August 24, 1984

HOPE CREEK GENERATING STATION  
DOCKET NO. 50-354  
FSAR CHANGES RESULTING FROM LICENSEE QUALIFICATIONS BRANCH  
MEETING JULY 23, 24, AND 25, 1984

FSAR changes resulting from Licensee Qualifications Branch meeting - July 23, 24 and 25, 1984.

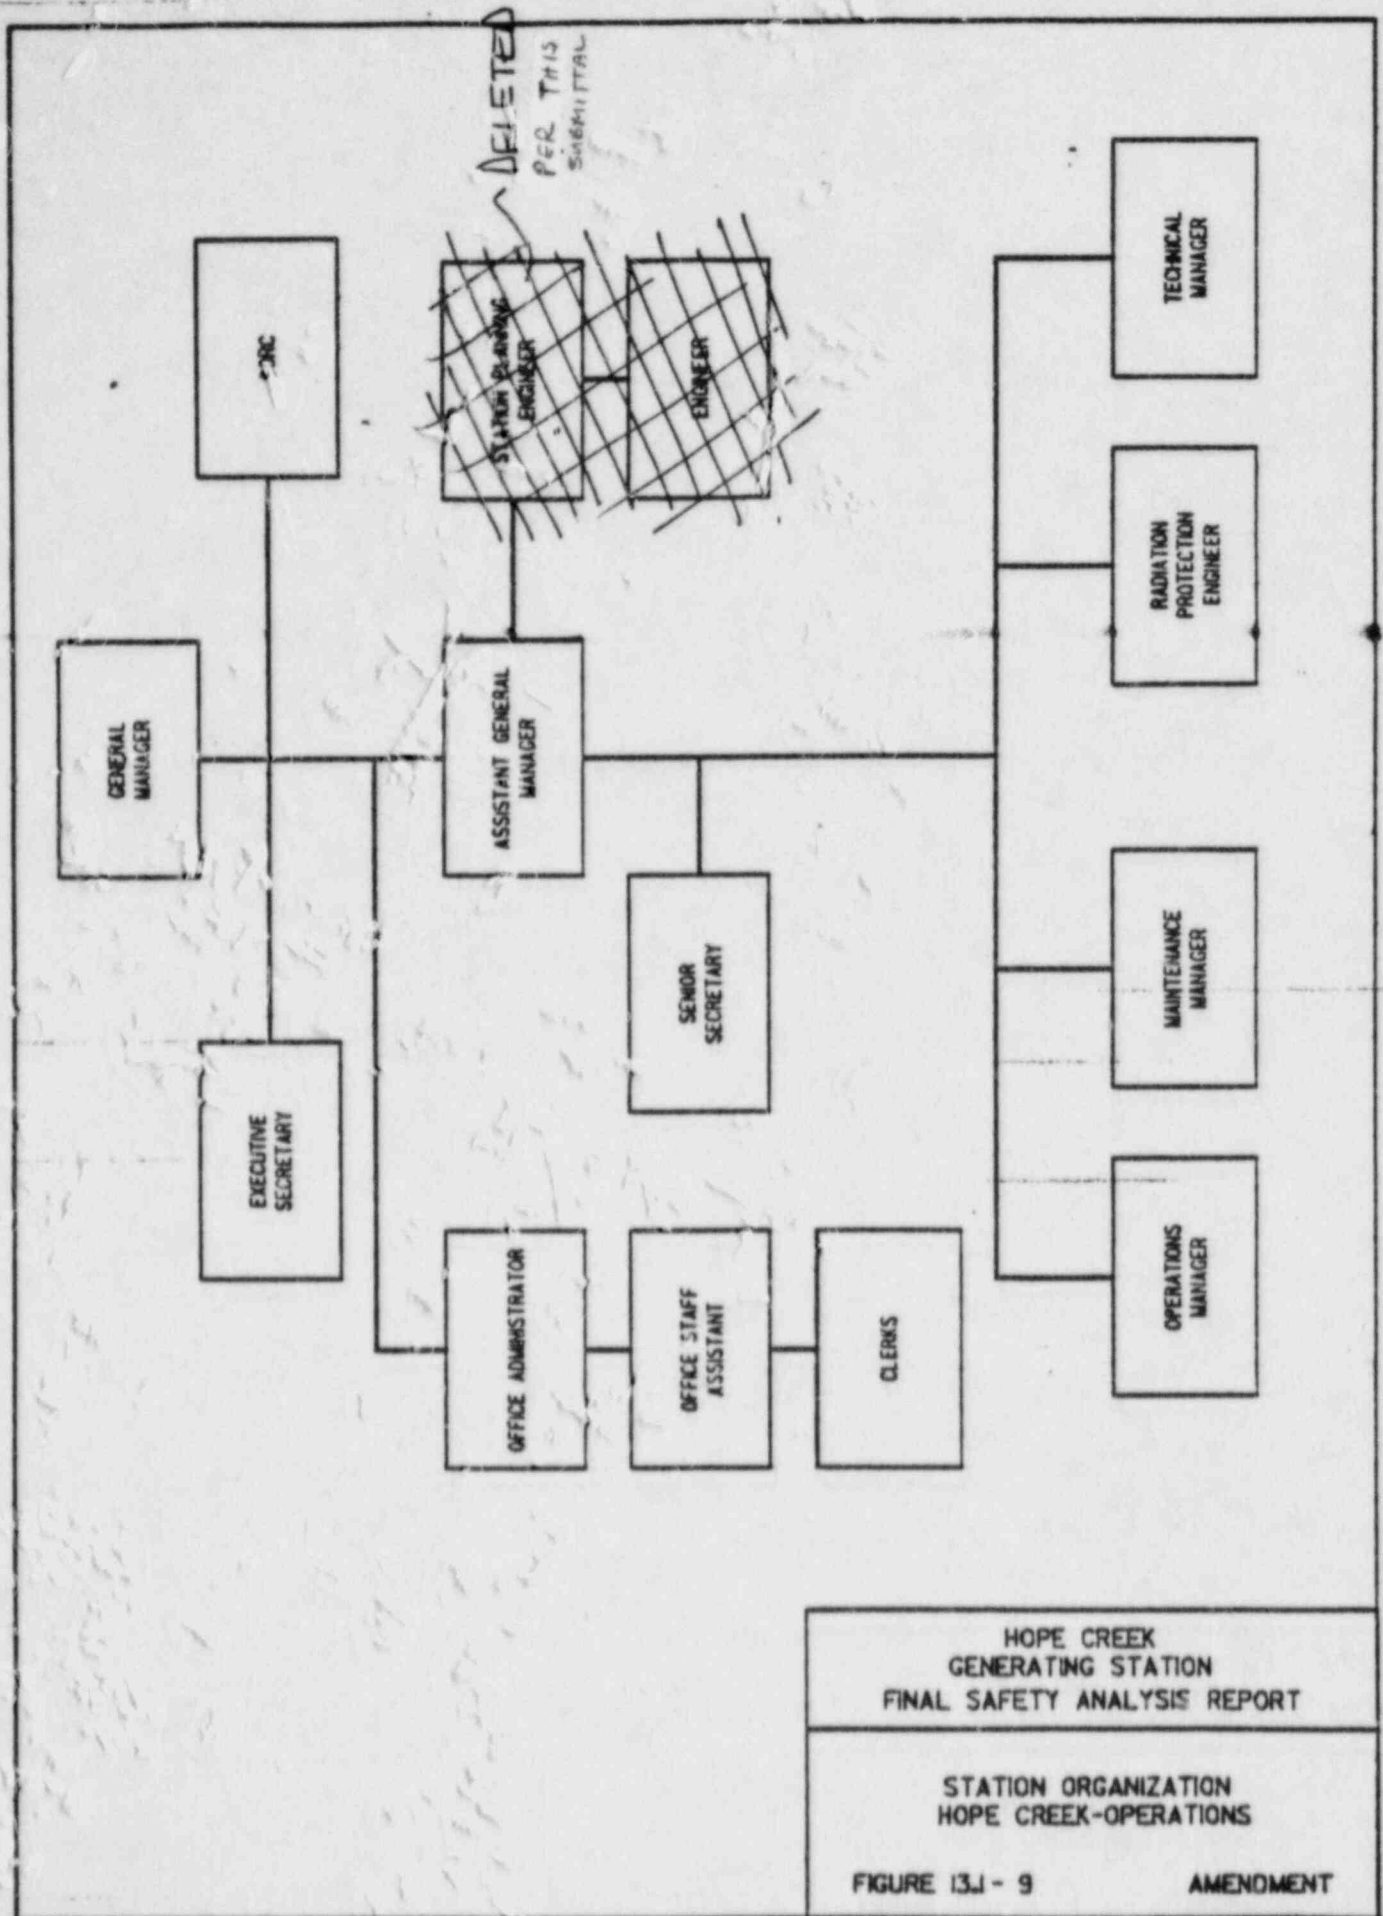
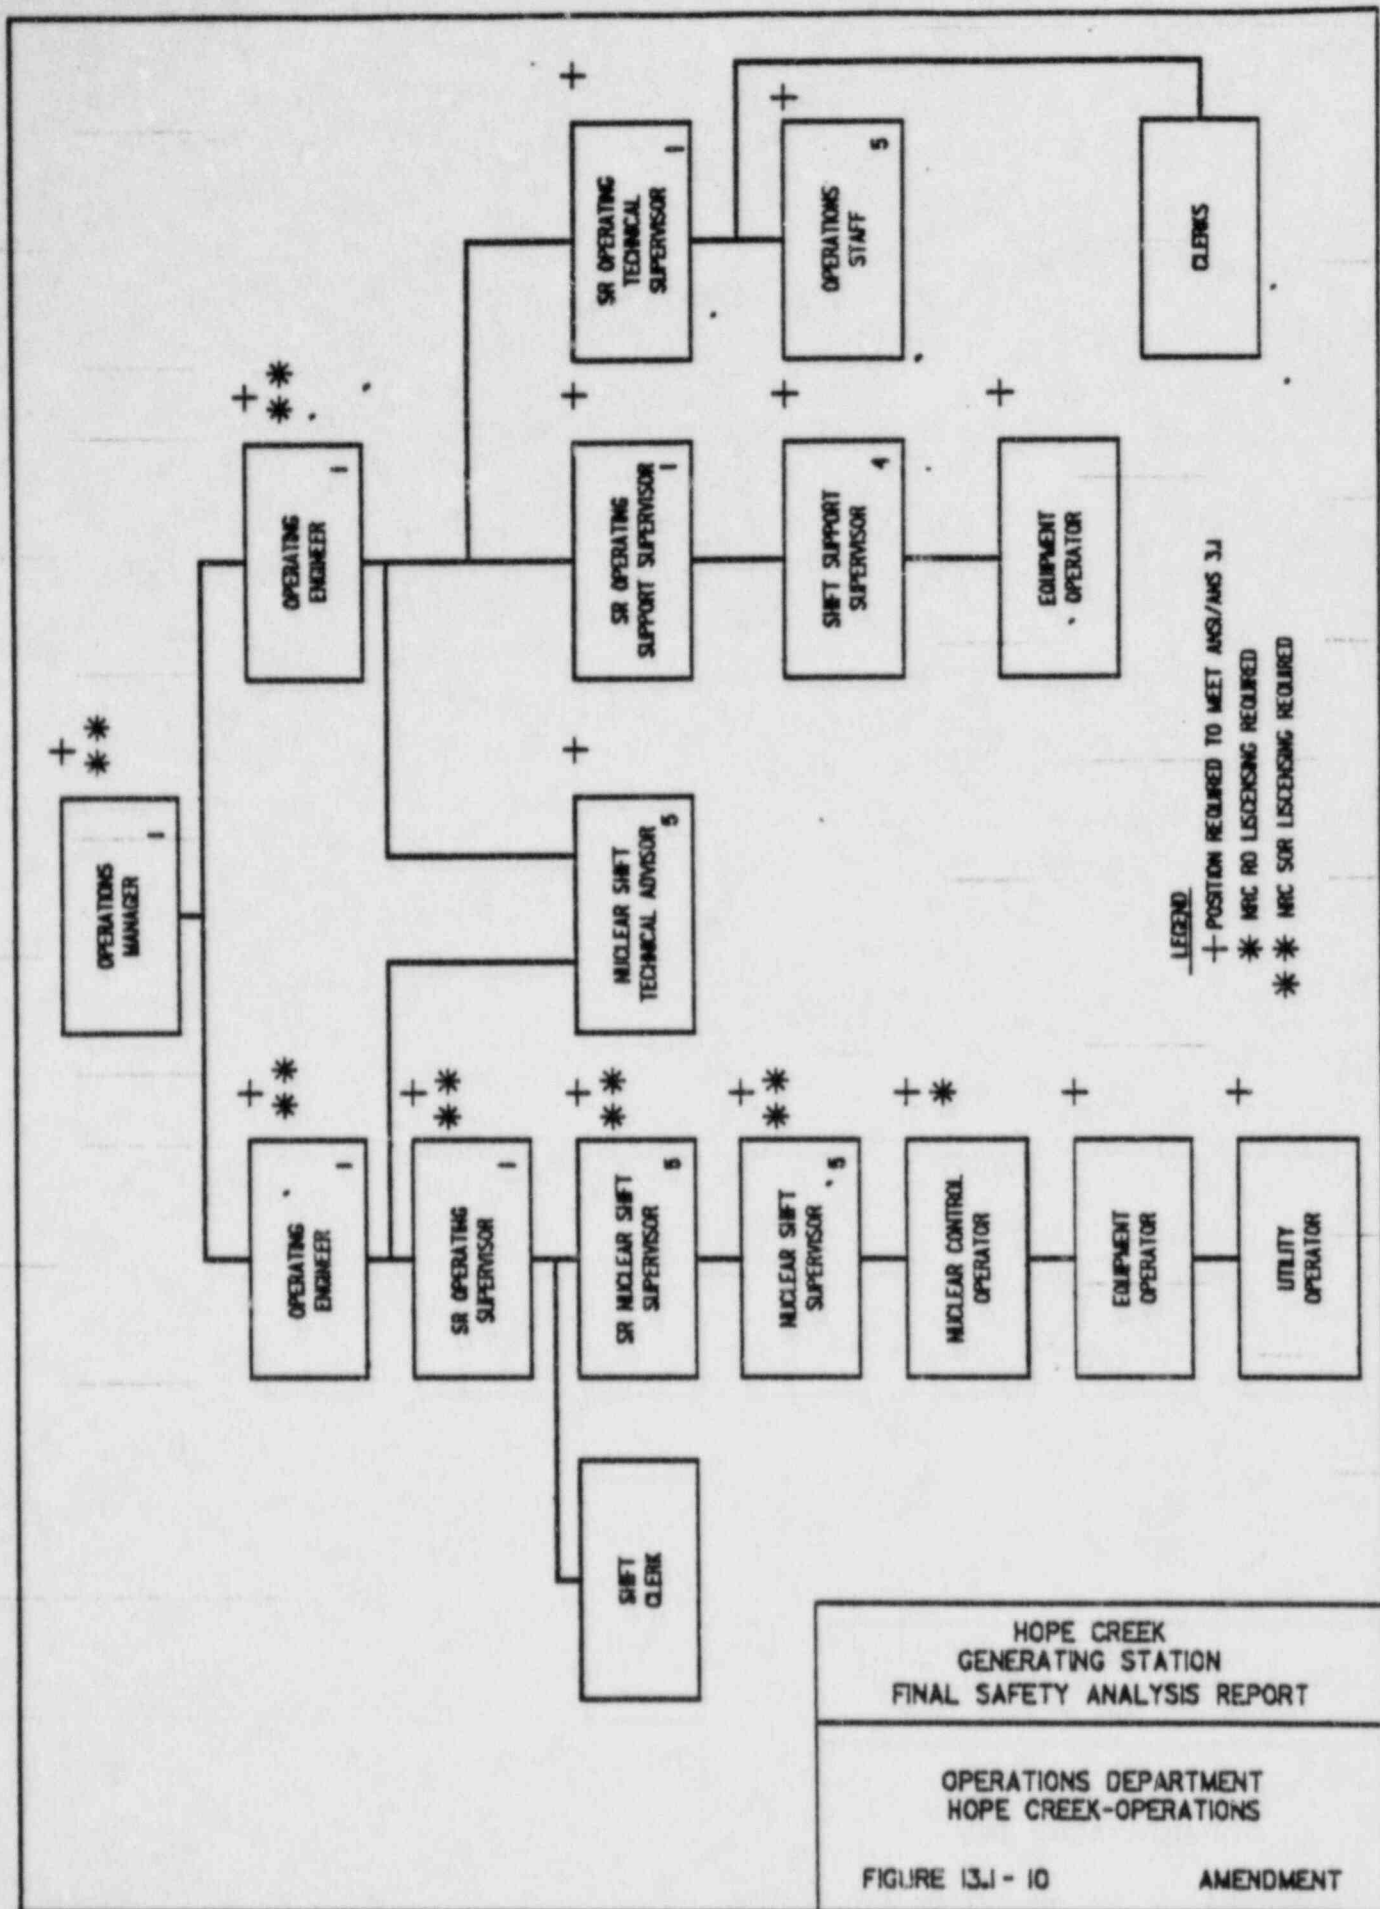
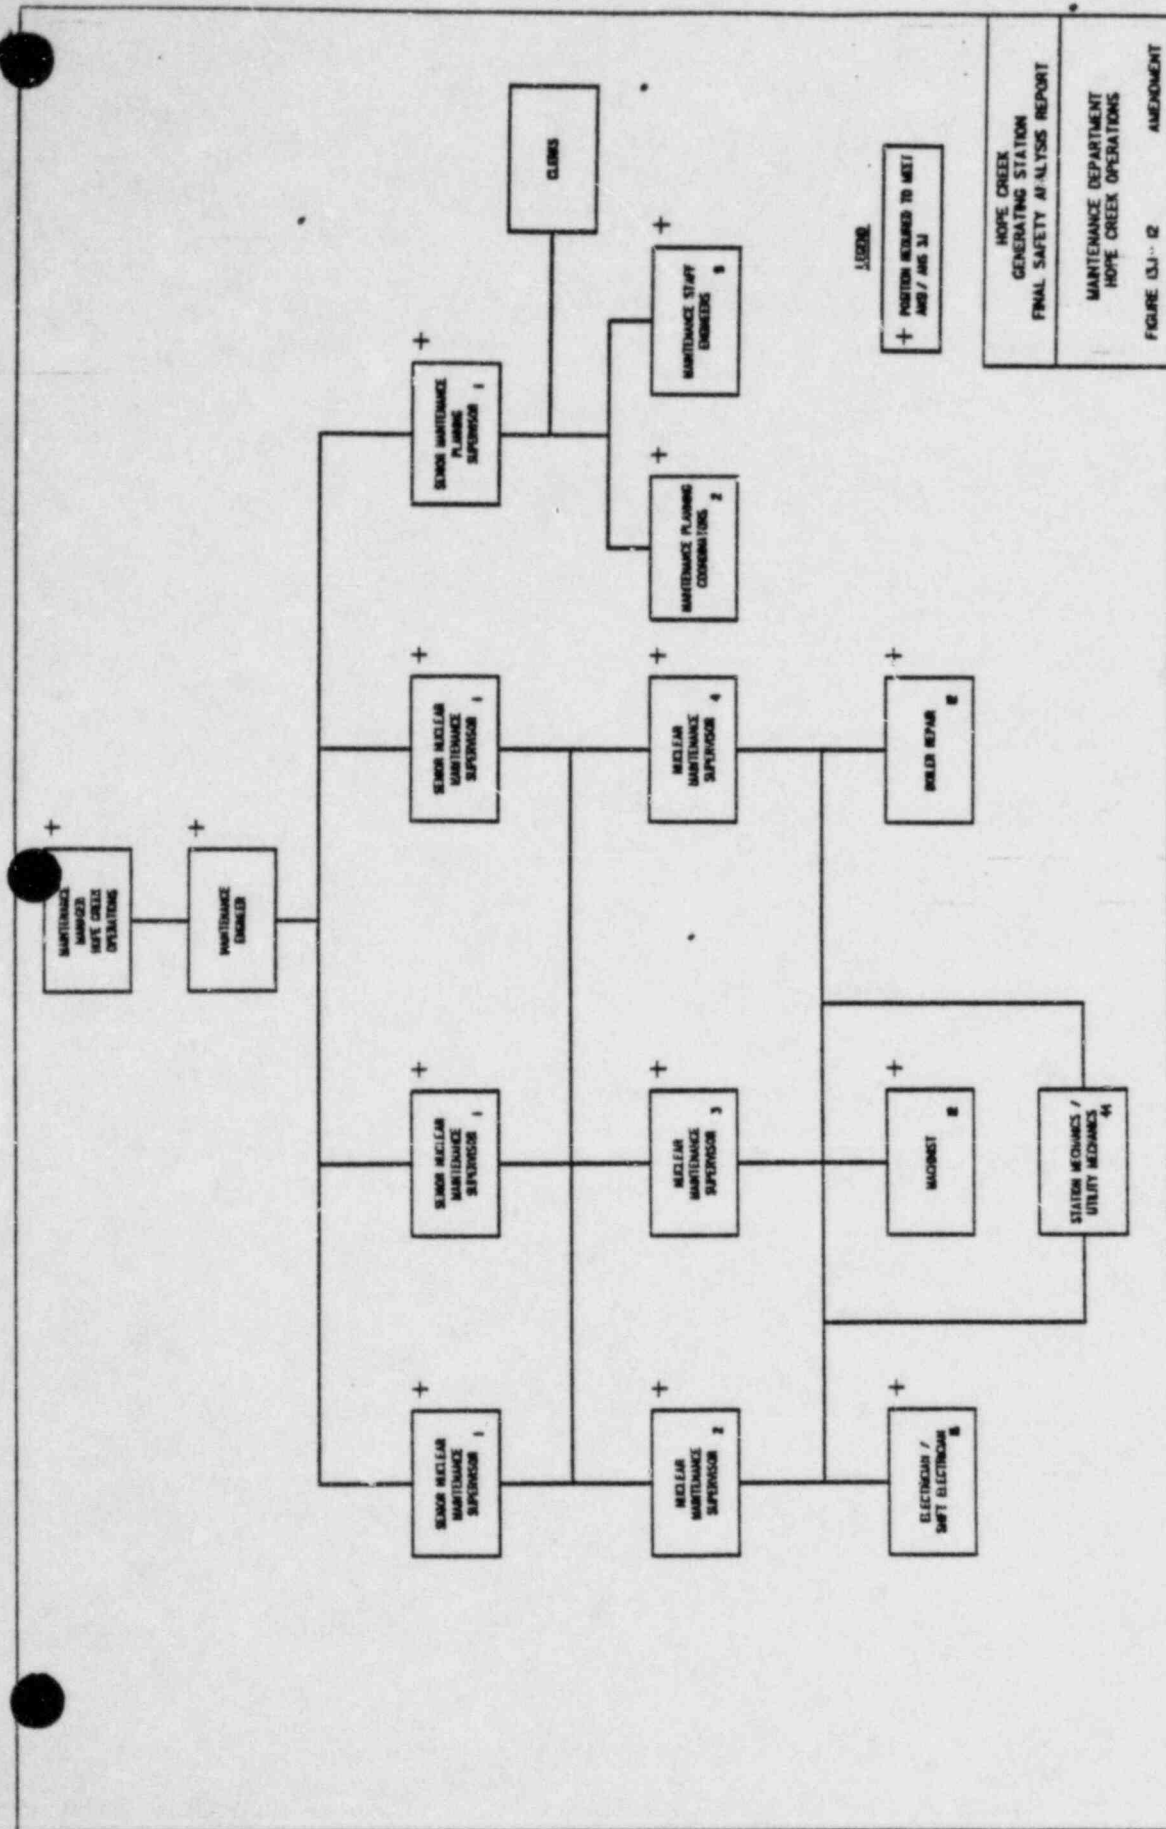
- 1) Correction to FSAR Figure 13.1-9 submitted previously (letter from R. L. Mittl, PSE&G, to A. Schwencer, NRC, dated August 3, 1984).
- 2) Revision to FSAR Page 1.10-21, TMI item I.C.6 which was submitted previously on aforementioned letter. (This revision is in response to a telecon with F. Allenspach, NRC Licensee Qualifications Branch).

- 1) Correction to FSAR Figure 13.1-9 submitted previously (letter from R. L. Mittl, PSE&G to A. Schwencer, NRC, dated August 3, 1984).
- 2) Revision to FSAR Page 1.10-21, TMI item I.C.6 which was submitted previously on aforementioned letter. (This revision is in response to a telecon with F. Allenspach, NRC Licensee Qualifications Branch).
- 3) Resubmittal of modifications to FSAR Chapter 13 and Section 1.10 discussed at the NRC/PSE&G Licensee Qualifications Branch meeting held July 23, 24 and 25, 1984, previously submitted via letter from R. L. Mittl, PSE&G, to A. Schwencer, NRC, dated August 3, 1984.
